# 7.5 MW Waste-to-Energy Power Plant by Goodwatts WTE Jamnagar Private Limited in Gujarat, India

Document Prepared by (LGAI Technological Center S.A. (Applus+  
Certification))

<b>Project Title</b>	<i>7.5 MW Waste-to-Energy Power Plant by Goodwatts WTE Jamnagar Private Limited in Gujarat, India</i>
<b>Version</b>	<i>02.1</i>
<b>Report ID</b>	<i>18123</i>

<b>Report Title</b>	<i>7.5 MW Waste-to-Energy Power Plant by Goodwatts WTE Jamnagar Private Limited in Gujarat, India</i>
<b>Client</b>	<i>Kosher Climate India Private Limited</i>
<b>Date of Issue</b>	<i>07/08/2024</i>

Figure 1: project boundary of the project activity

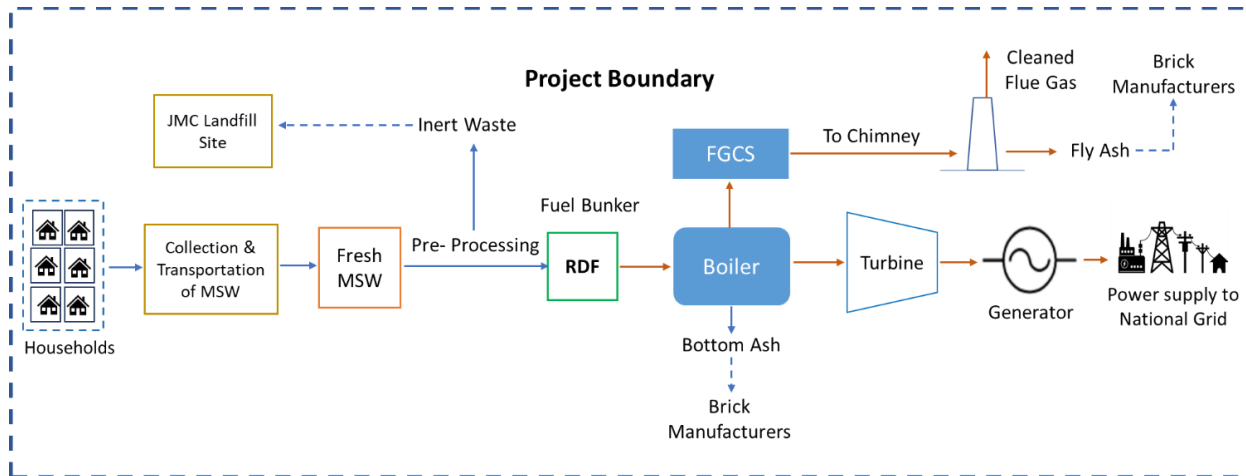
VVB noted that, all these are clearly demonstrated and considered in the project boundary and hence acceptable,

This is clearly demonstrated in the below diagram by PP which is acceptable.

According to paragraph 18 of AMS-I. D, version 18, the spatial extent of the project boundary includes the project power plant and all power plants connected physically to the electricity system that the CDM project power plant is connected to.

Thus, in line with the applicable methodology PP has considered project power unit and existing national electricity grid to which this plant is connected to. The project activity involves incineration of RDF prepared from MSW and generated electricity is exported to the national grid. VVB noted that, all these are clearly demonstrated and considered in the project boundary and hence acceptable.
